CR183 – Battery fastening updates

Hypermotard 950 Model Year 2019-2020

Safety Recall Campaign SRV-RCL-19-003

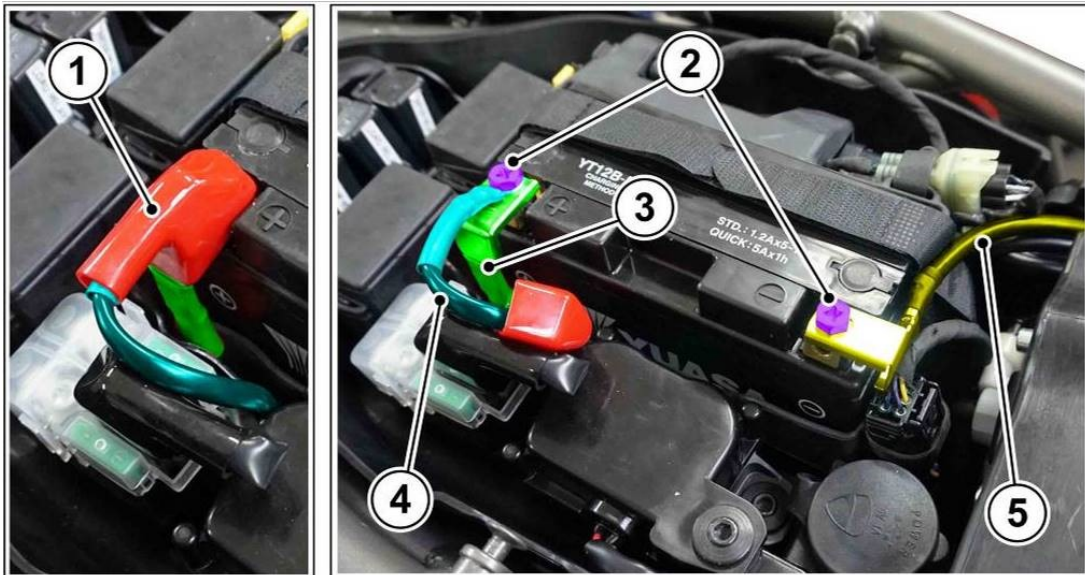
1. Position the motorcycle on the central paddock stand
2. Remove the seat (See Sec.5: "Fairing installation – Seat" of the Workshop Manual)
3. Remove protective **cap (1)** from battery positive terminal pole and loosen the **2 screws (2)** retaining **motorcycle negative cable (5)** to battery negative terminal pole and **motorcycle positive cable (3)** and **ABS positive cable (4)** to battery positive terminal pole

4. Loosen **strap (6)** and remove battery from the relevant rubber **mat (7)**

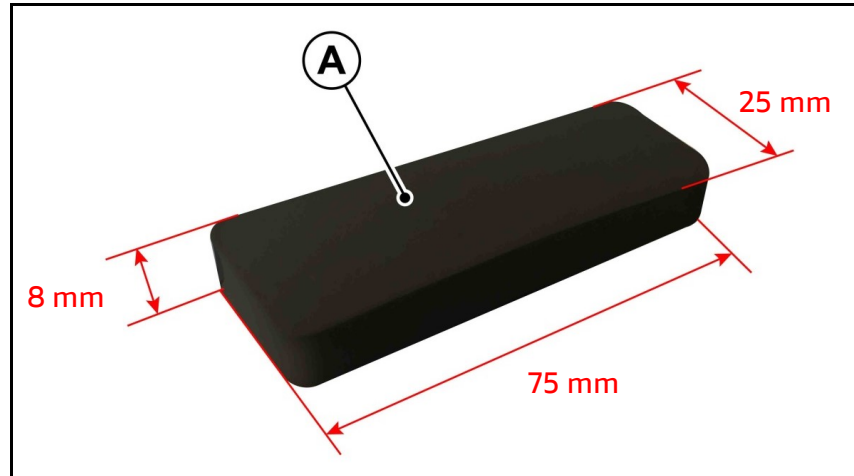
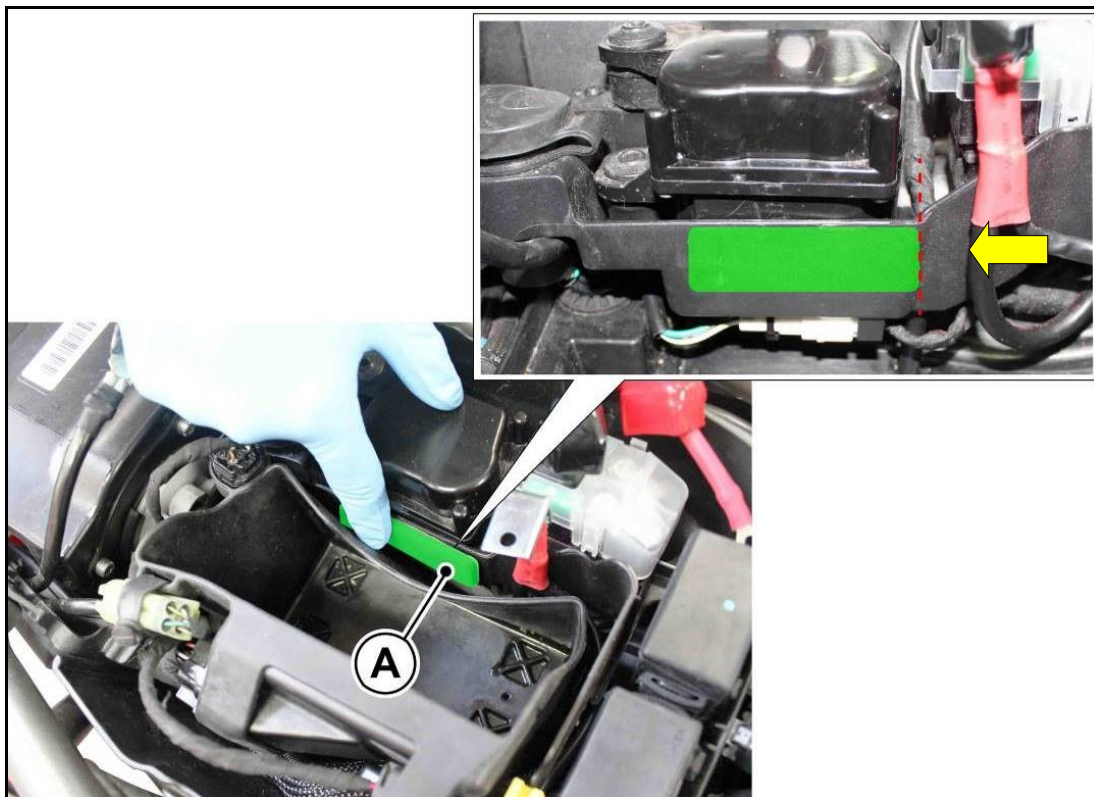
5. Identify the black neoprene **pad (A)** Part no.86611871A (75x25x8mm)

6. Remove the protective film from **pad (A)** and apply pad inside the electrical components support compartment.

Apply **pad (A)** starting from the curved profile of electrical components support compartment, as shown in the figure.

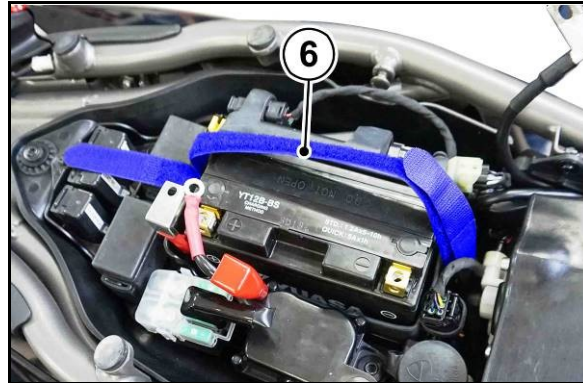
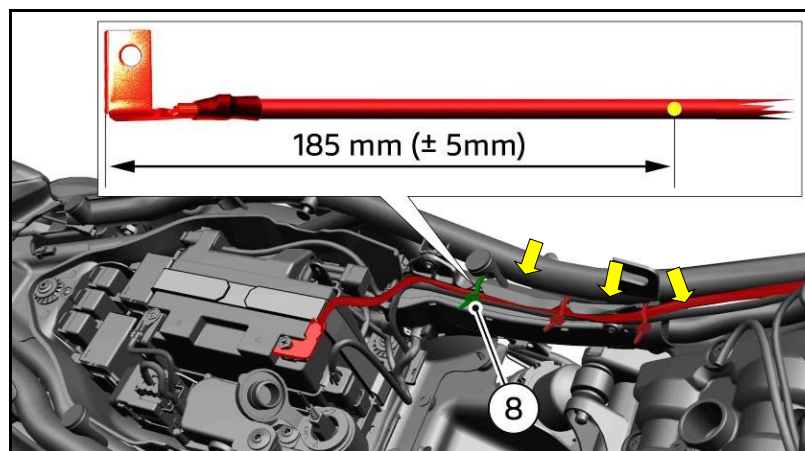
7. Position battery inside the relevant mat aiming it as shown in the figure and without pulling strap (6)

Prior to fastening the positive battery cable to the battery terminal, check that the length of battery negative terminal cable free section between the end of terminal and small self-locking tie (8) is 185 ± 5 mm.

If the measured length is incorrect, slide out the cable and lubricate the area close to the 3 ties with silicone spray in order to restore the correct position.

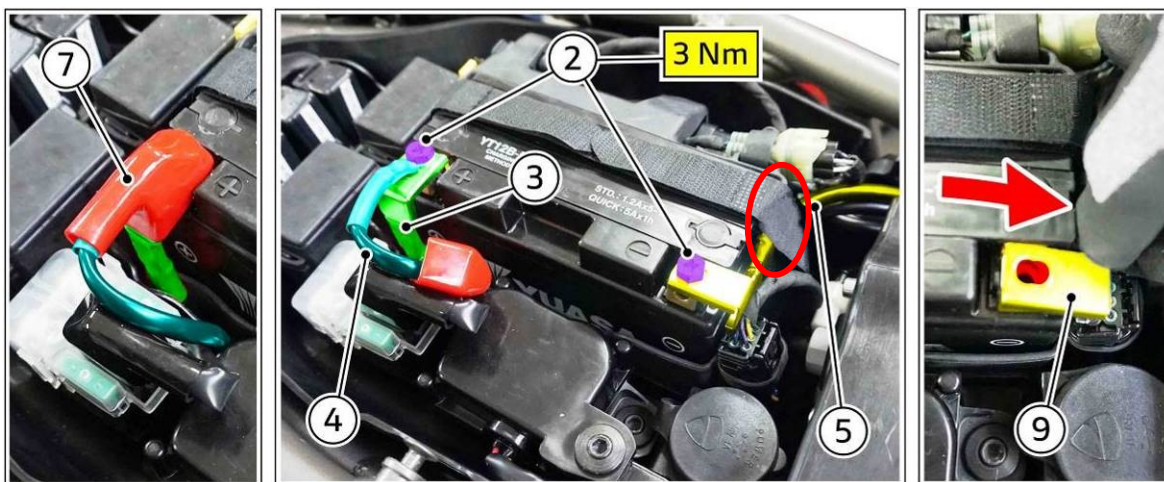
8. Fasten **motorcycle positive cable (3)** and **ABS positive cable (4)** to the battery positive terminal as shown in the figure
9. Fasten **motorcycle negative cable (5)** to battery negative terminal in the direction shown in the figure
10. Tighten the **2 screws (2)** to **3 Nm**

The **eyelet (9)** of **motorcycle negative cable (5)** has a slot, so it should be fastened by setting it as far away from the battery as possible, as shown in the figure.

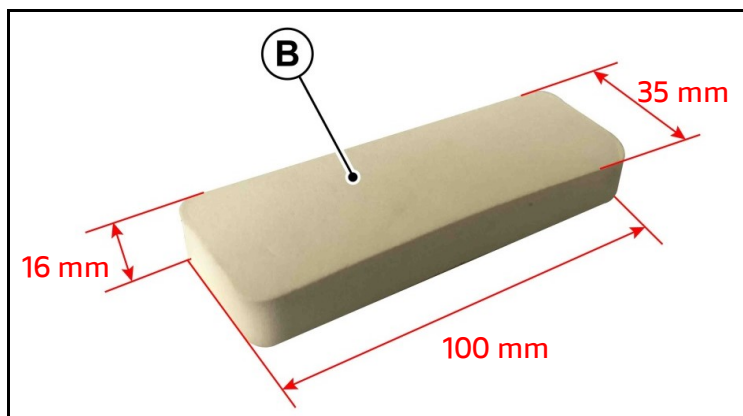
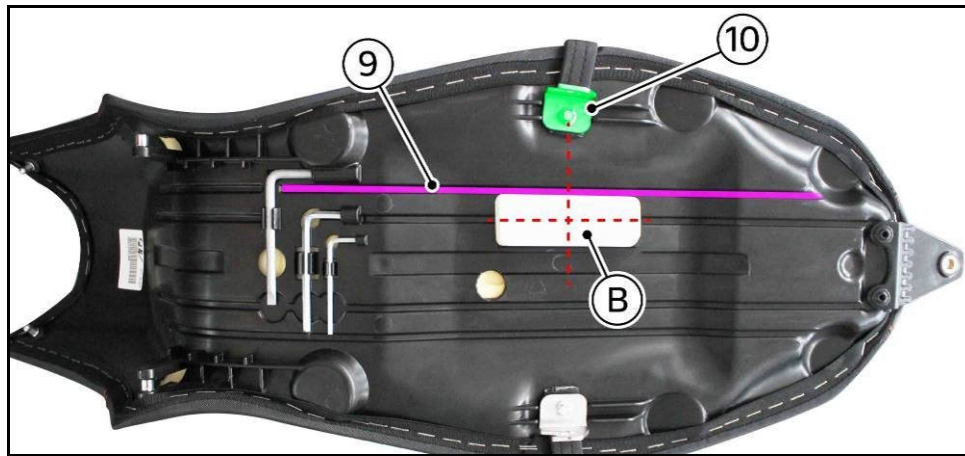
11. Then position **cap (7)** on positive terminal, as shown in the figure, and secure battery in place by pulling strap ends as shown in the figure.

Make sure the **motorcycle negative cable (5)** is positioned below the strap, as shown in the figure.

12. Identify the white neoprene **pad (B)** Part no.86613001A (100x35x16mm)

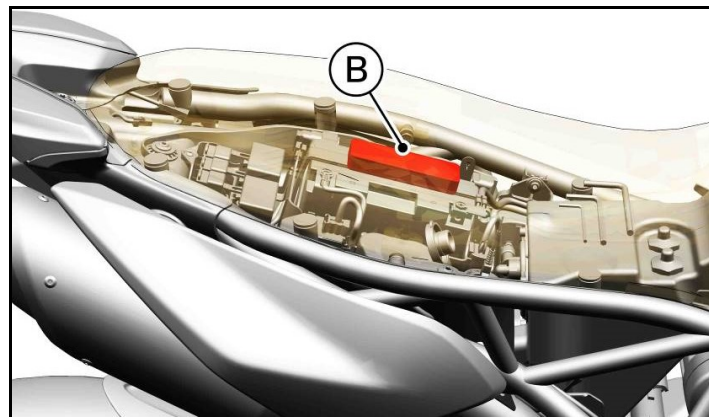
13. Remove the protective film from **pad (B)** Part no.86613001A and apply pad under the seat in order to further improve battery stability. Apply **pad (B)** with the following steps:

- Turn the seat from the inside
- Locate the **first groove (9)** starting from seat fastening **LH hook (10)**
- Position **pad (B)** longer side (100 mm) close to **groove (9)** and center it with **LH hook (10)**, as shown in the figure

When positioning seat on vehicle, make sure that **pad (B)** is close to battery fastening strap, as shown in the figure.

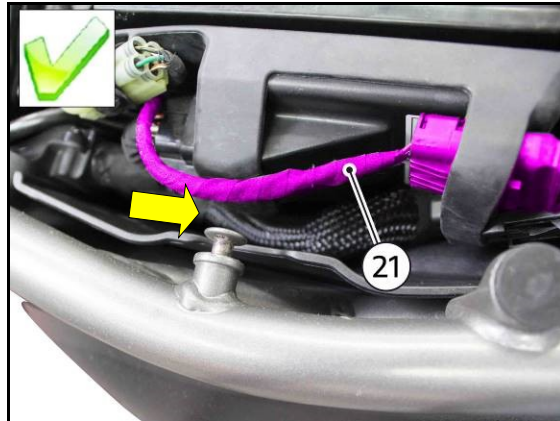
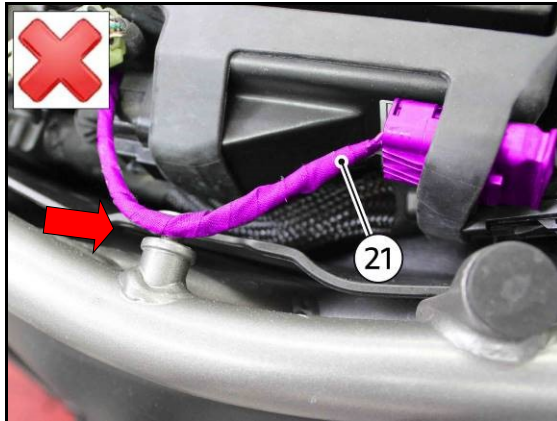
When fitting the seat, make sure that diagnostic socket connector **cable (21)** is NOT positioned in contact with the seat LH anchoring pin, as shown in the figure.
